## SECTION 00 63 13 REQUEST FOR INFORMATION FORM

Project: <u>Environmental Mitigation of Facility</u>	R.F.I. #: <u>1</u>
<u>At 401 Galaxy Avenue</u>	From: <u>North of the River Recreation &amp; Park Dist.</u>
To: <u>Bidding Contractors</u>	Date: <u>03.26.20</u>
Re: <u>Document Clarification</u>	Proj. #: <u>NOR-2-1920</u>

PLUMBING PLAN scale 1/8"=1'-0"

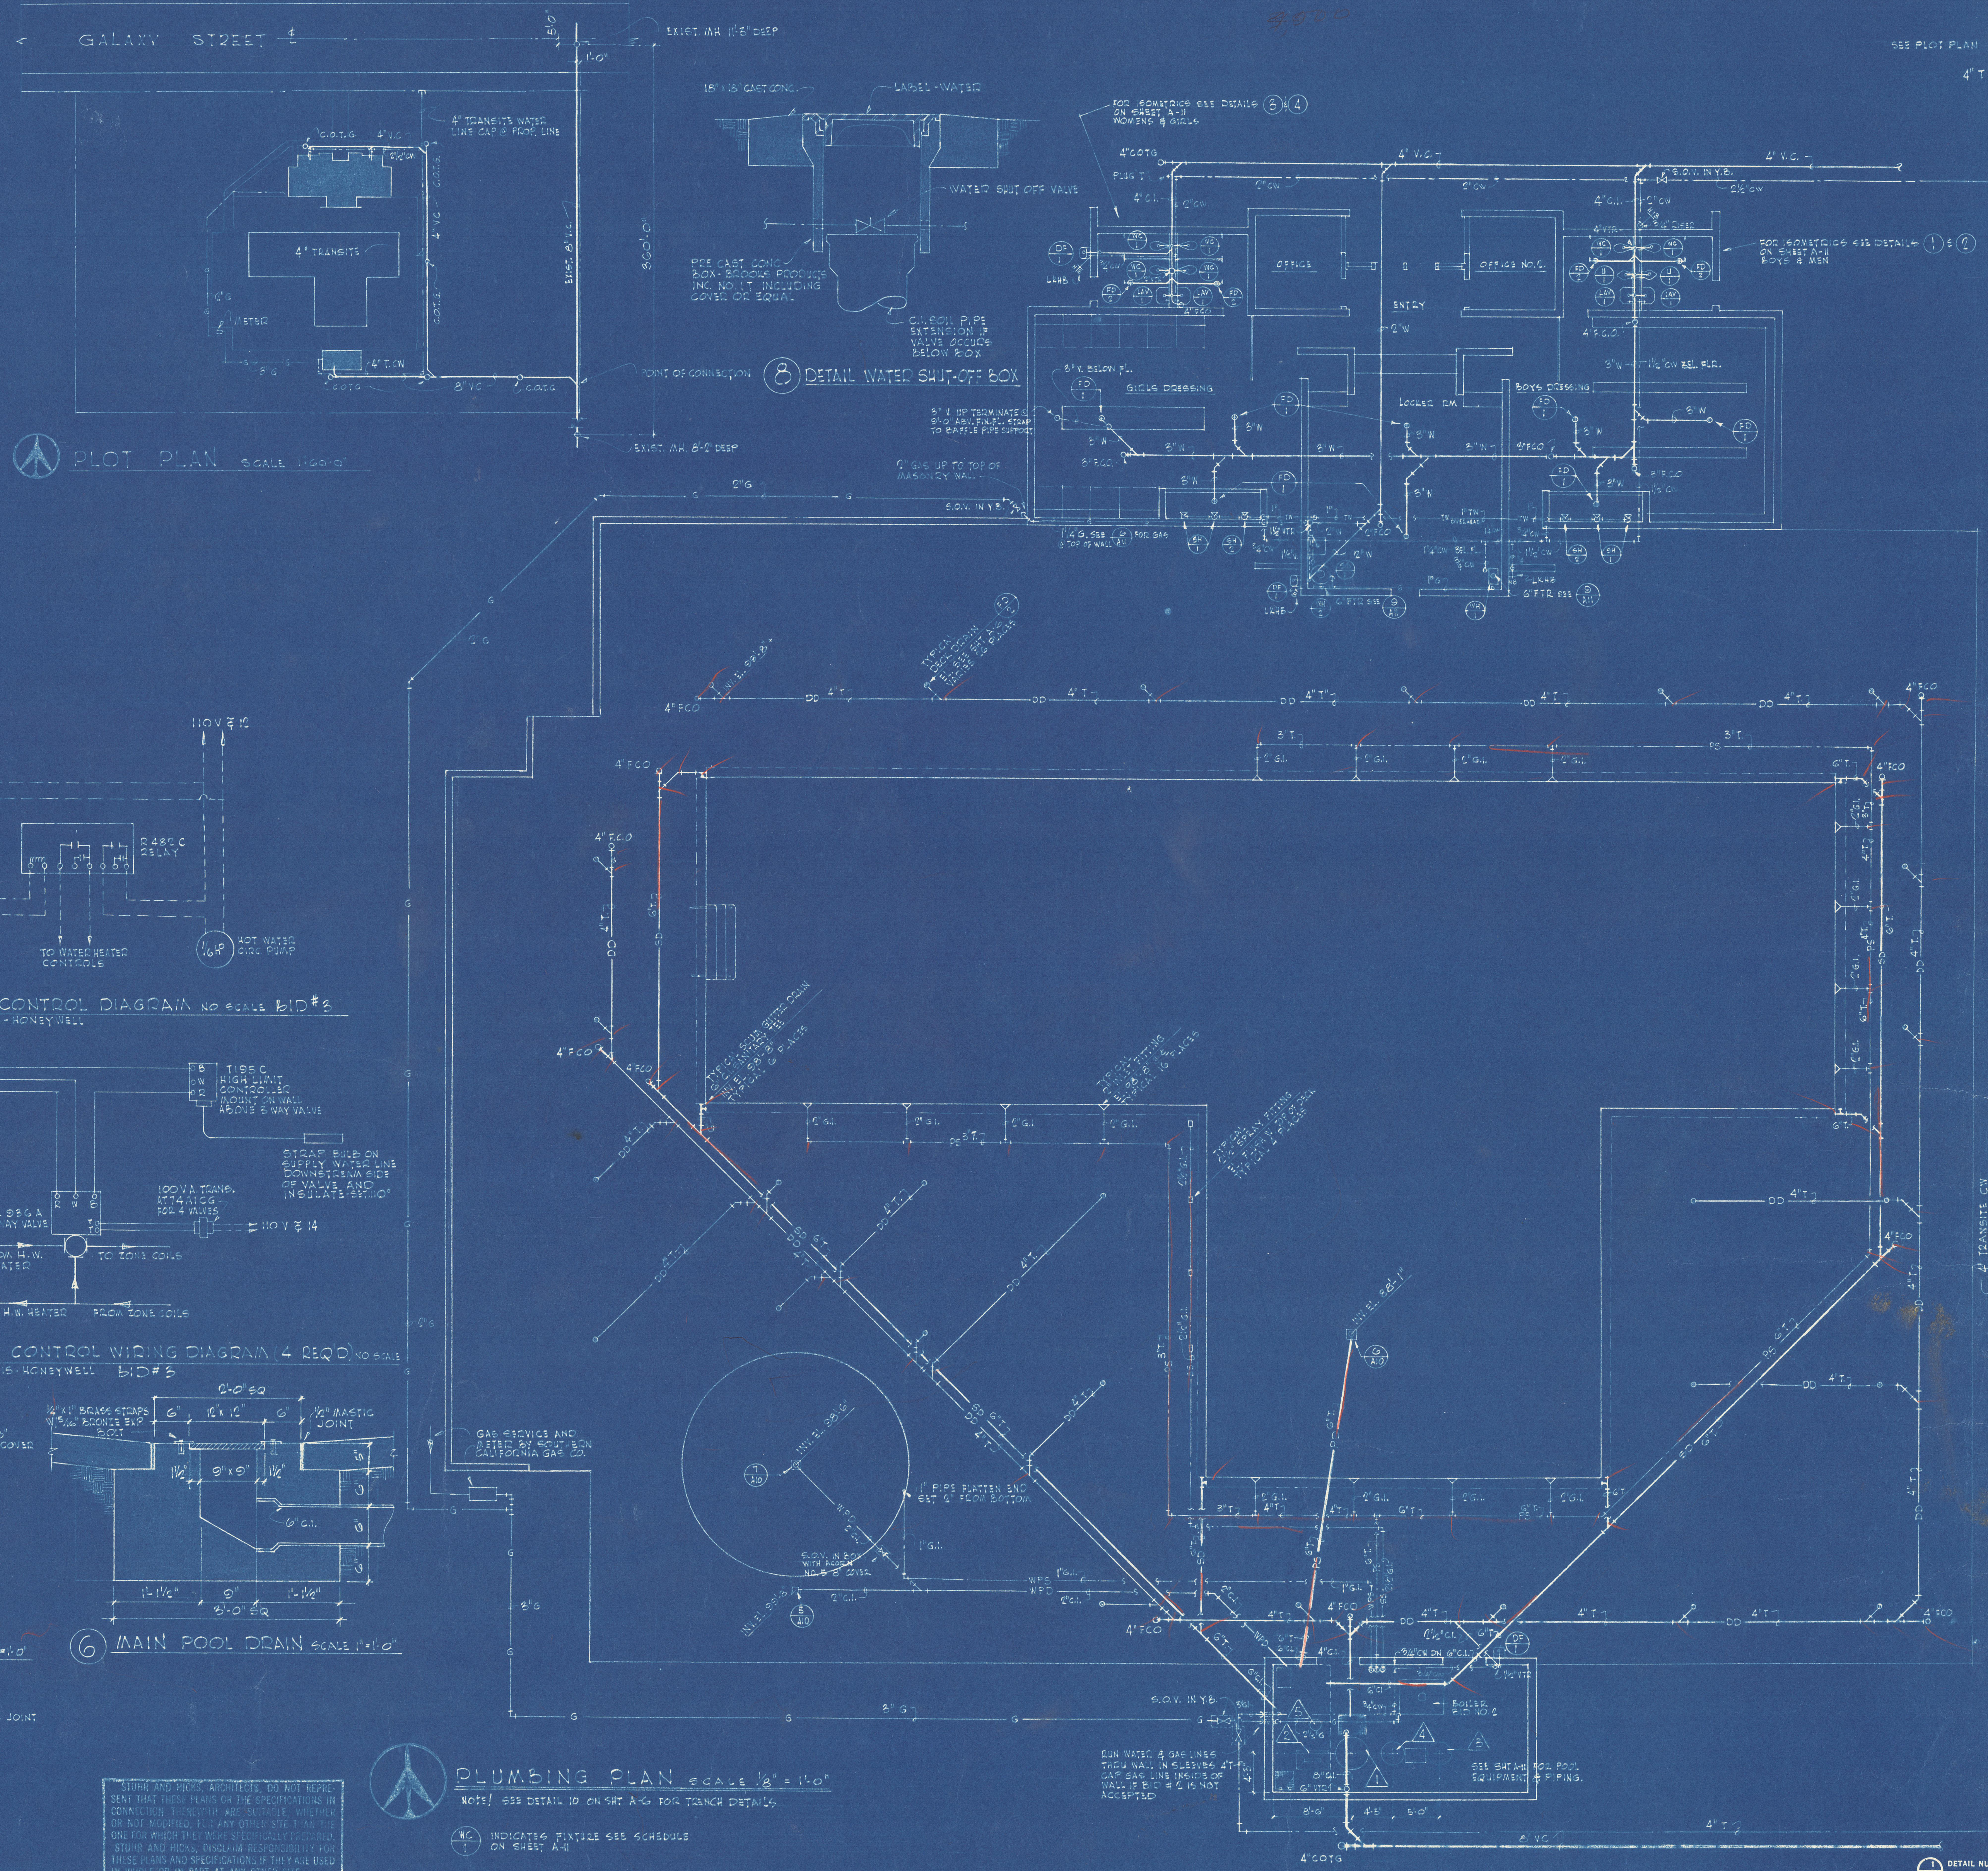
See attached original blueprint of the plumbing piping plan. Verify all inlet and outlet locations; facility remains per original construction.
